begin LBNC comments in italic

Calibration: We consider this part to be generally in good shape. Also, the talk clarified well the roles of the various calibration signals (those that come for free and those that are planned to be installed). The questions below in part go beyond the physics TDR itself.

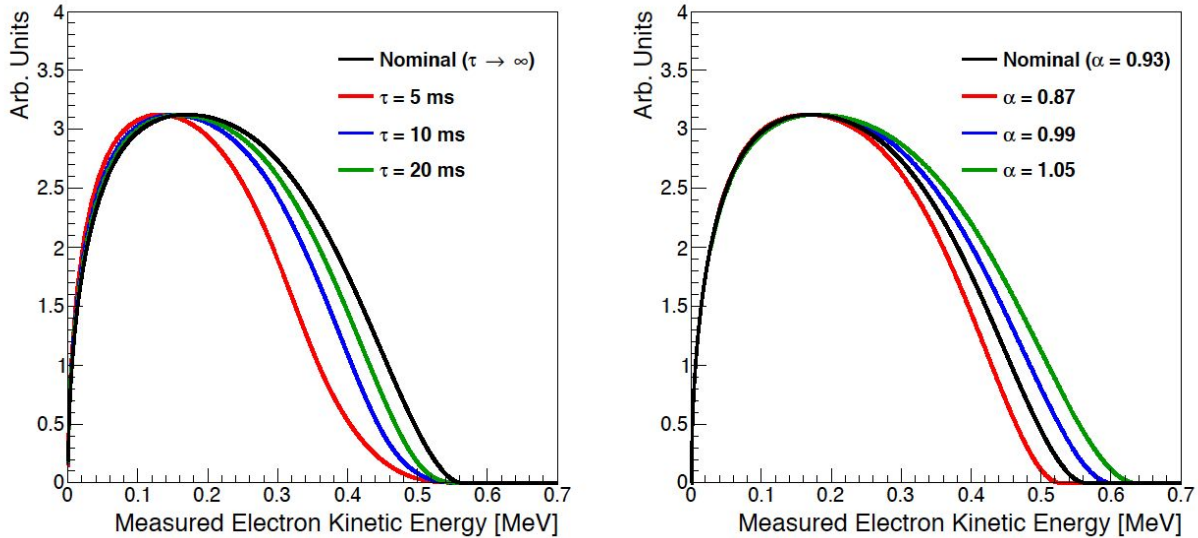
(i) What are the exact inputs expected from CAPTAIN? How important are these inputs, and how much impact is there if CAPTAIN can't deliver these inputs?

Our uncertainties do not currently rely on CAPTAIN inputs. Generous uncertainties are assigned in the detector response. (Mini) CAPTAIN has released new results which will be used to improve the detector model.

The uncertainties in the LBL analysis include uncertainties on both the neutron detector response model and also on the neutrino interaction model. Calibration informs the first category. At the time of the TDR writing, CAPTAIN had not released results. The neutron response uncertainties were determined based on previous single-detector/calorimetry analyses (MINERvA) and corresponded to 20% on neutron energy scale. This assumes that the disagreements between existing models and data are: 1) similar between C and Ar and therefore comparably sized for Ar, and 2) the entire source of the discrepancy is attributed to the detector model.
